ENGINE - REWORK THE BIFURCATION DISCONNECT PANEL ASSEMBLY TO EXTEND SEALING FEATURES -
CATEGORY CODE 4 - MOD.ENG-72-0062

V2500-ENG-72-0062

SERVICE BULLETIN

Bifurcation Panel
Fig.1

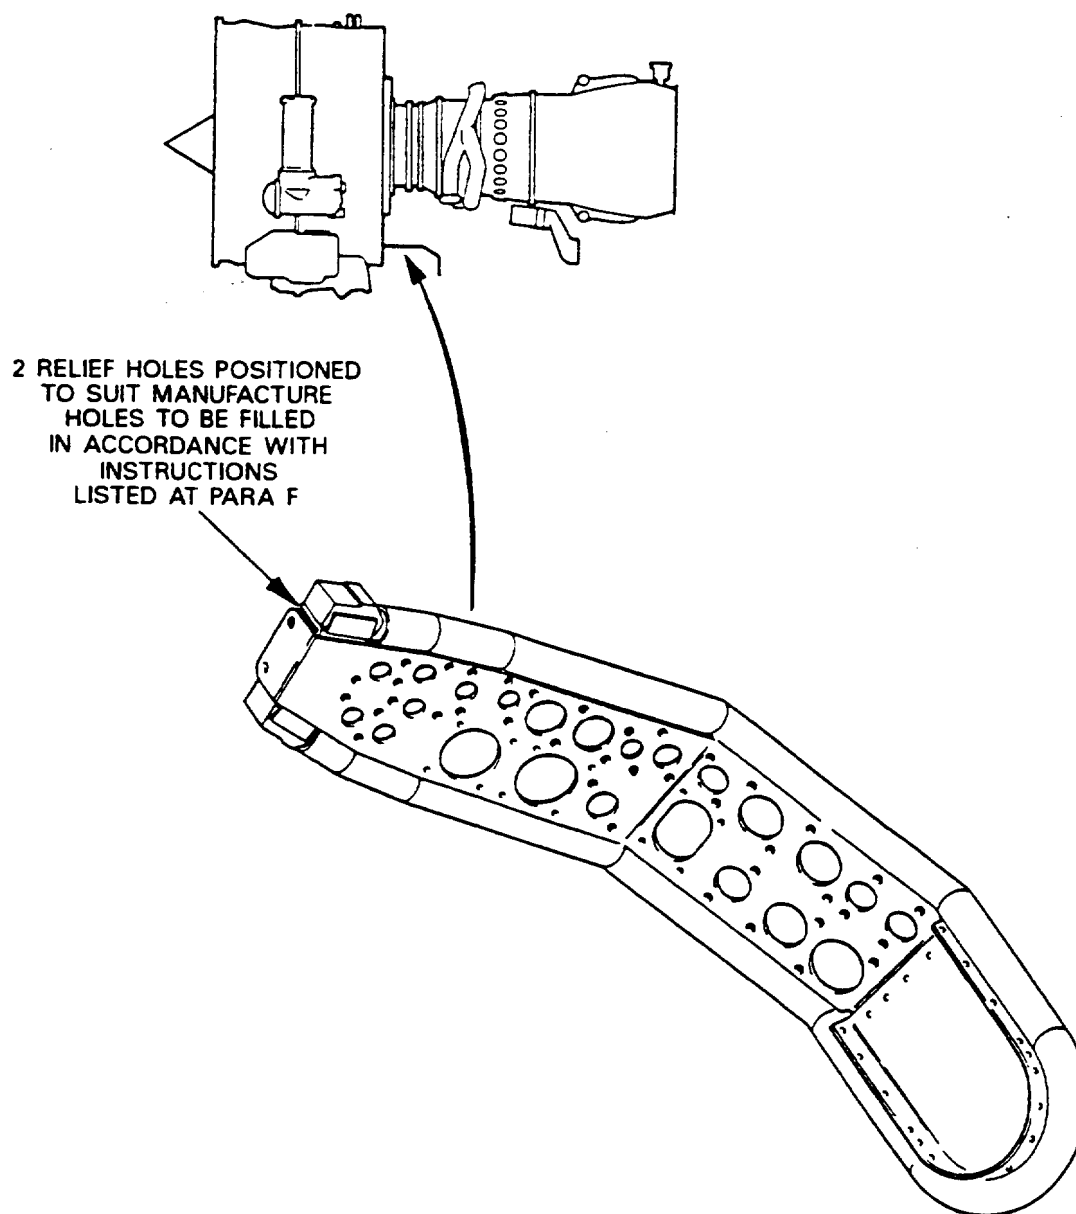
- (3) Place warning notice on cockpit panel SUBTASK 78-32-00-869-401.
- (4) Open the cowl panel SUBTASK 78-32-00-010-404.
- (5) De-activate hydraulic control unit SUBTASK 78-32-00-040-403.
- (6) Open thrust reverser half SUBTASK 78-32-00-010-407.
- (7) Locate Bifurcated disconnect panel 6A3361 (See fig.1).
- (8) Apply cold curing Silicone compound CoMat 08-013 to the two manufacturing holes in accordance with:

SUBTASK 70-36-02-360-020. TOTAL: 30 mins.
- (9) Close thrust reverser half SUBTASK 78-32-00-440-403.
- (10) Activate hydraulic control unit SUBTASK 78-32-00-440-403.
- (11) Close cowl panel SUBTASK 78-32-00-410-408
- (12) Remove warning notices SUBTASK 78-32-00-942-400.
